# Transient section 145.3.8.6 v102

### 145.3.8.6 PD behavior during transients at the PSE PI

**Figure 145-31—Transient test conditions operating bounds**

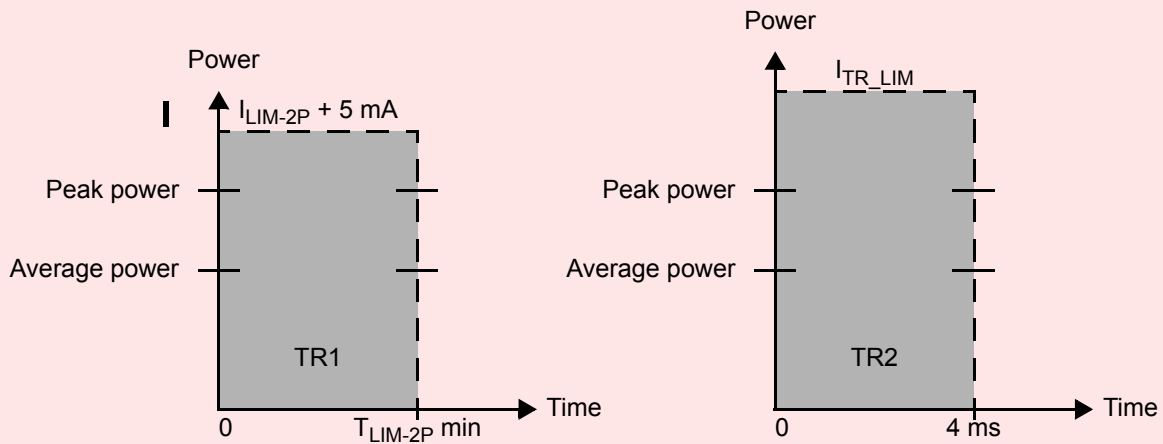
- Figure 145–31 tries to show an overview of the PD requirements when exposed to transients TR1 and TR2. Issues:
- The Figure and description of parameters used is a complete duplicate of normative information in the same subclause
  - It doesn't add any new information or insight
  - The Figure y axis is labeled “power” but at the top of the box a current level is denoted
  - $T_{LIM-2P}$  (PSE parameter) is tied to PSE Type. It is 10 ms for Type 3 and 6 ms for Type 4. The PD does not see the difference between a Type 3 and a Type 4 PSE, hence the reference to  $T_{LIM-2P}$  needs to be replaced by “6 ms”.

Table 145–29 defines two PSE transient conditions and PD Types to which these apply. ~~Figure 145–31 shows operating bounds for the transients in Table 145–29. The shaded regions begin with the application of the transient and end at the times indicated in the Figure. These shaded regions can exceed normal operating limits and are not included in the average and peak operating power requirements set forth in Table 145–28.~~

Having a dependence to  $T_{LIM-2P}$  in the PD section per D2.4 is an issue, since the value of  $T_{LIM-2P}$  depends on Type. The PD can't see the difference between Type 3 and Type 4.

The proposed resolution is to remove the Figure and description and correct the text accordingly.

When the PD is operating under its worst-case current draw for its assigned Class and transient TR1 is applied, the PD shall meet the operating power limits after  ~~$T_{LIM-2P\ min} - 6\ ms$~~  as defined in ~~Figure 145-31~~ Table 145-28.

When transient TR2 is applied, the peak current shall not exceed  $I_{TR\_LIM}$ , as defined in Table 145-30, and the PD shall meet the operating power limits after 4 ms ~~as defined in Figure 145-31~~.
